REFERENCE:	Nova Bus Manuals
SECTION:	18: Articulation System
RS N°:	n/a
EFFECTIVE IN PROD.:	n/a

SUBJECT:	Articulation Potentiometer
JUSTIFICATION:	New Potentiometer available in service

Field Modification Instructions

Nova Bus
Potentiometer

Figure 6 Clearance Hole Enlargement

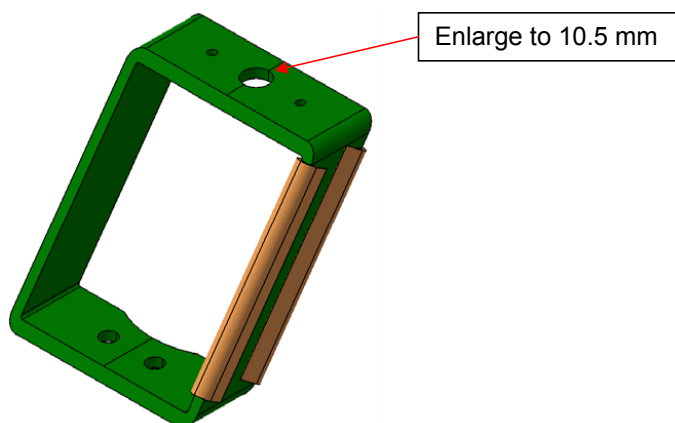
Using a 10.5 mm drill bit and drill, enlarge the center hole of the inverted bracket from 10 mm to 10.5 mm (See Figure 6).

Figure 7 Placement of Potentiometer

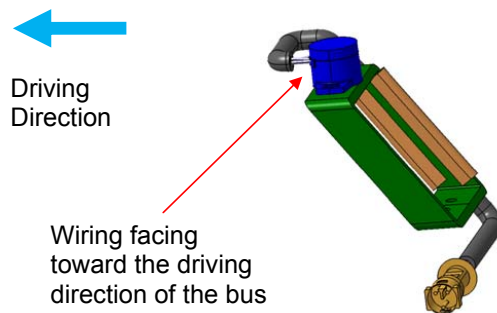
Next place the new potentiometer with the brass shaft on the inverted bracket with the wires of the potentiometer facing the direction indicated below (See Figure 7).

Figure 8 Potentiometer Installation

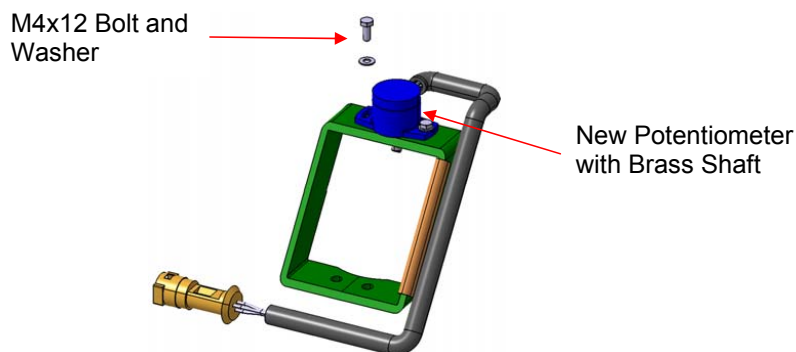
Install the two M4x12 bolts and washers that were previously removed to secure the new potentiometer to the inverted bracket (See Figure 8). Torque each bolt to 10 Nm.

Figure 9 Clamping Lever Positioning

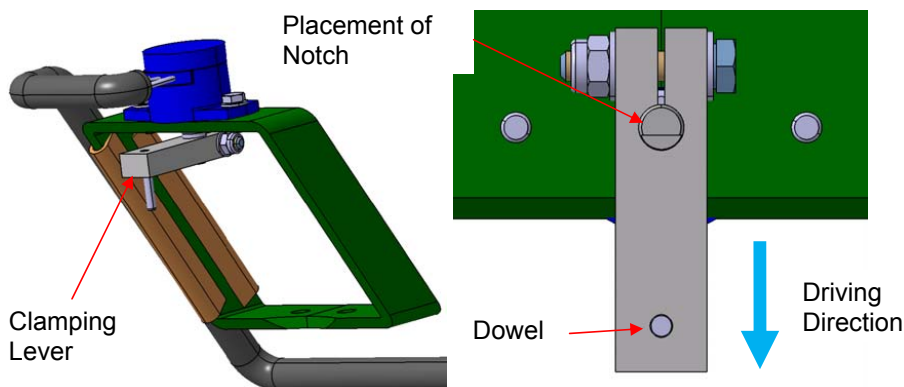
Install the clamping lever to the underside of the potentiometer. **The position of the clamping lever and the notch on the potentiometer is very critical to the functionality of the potentiometer.** The notch on the potentiometer should face the driving direction of the bus. Therefore, the notch will be closest to the dowel of the clamping lever (See Figure 9). Torque the bolt to 3 Nm.

Figure 10 Installation of the Potentiometer Assembly

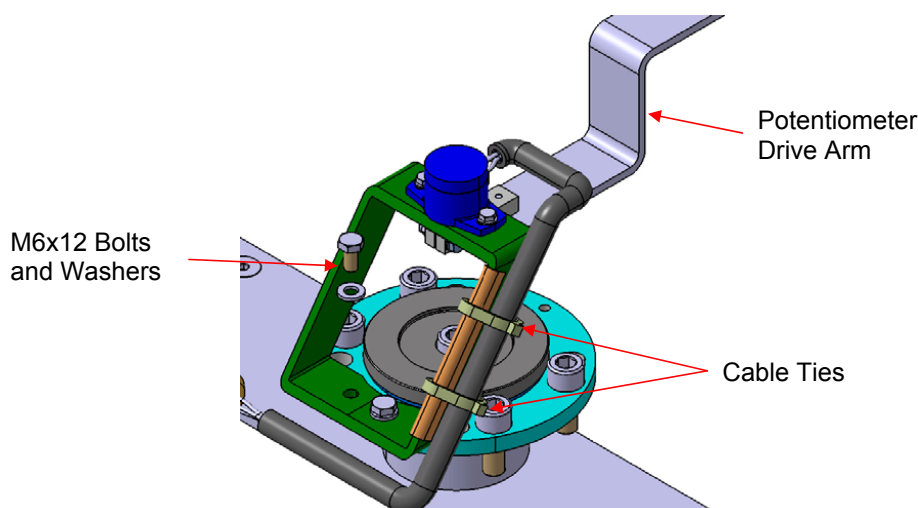
Place the potentiometer into the mounting position on the articulation. Carefully insert the dowel of the clamping lever into the potentiometer drive arm. Insert the two M6x20 bolts and washers to secure the inverted bracket to the articulation (See Figure 10). Torque each bolt to 10 Nm.
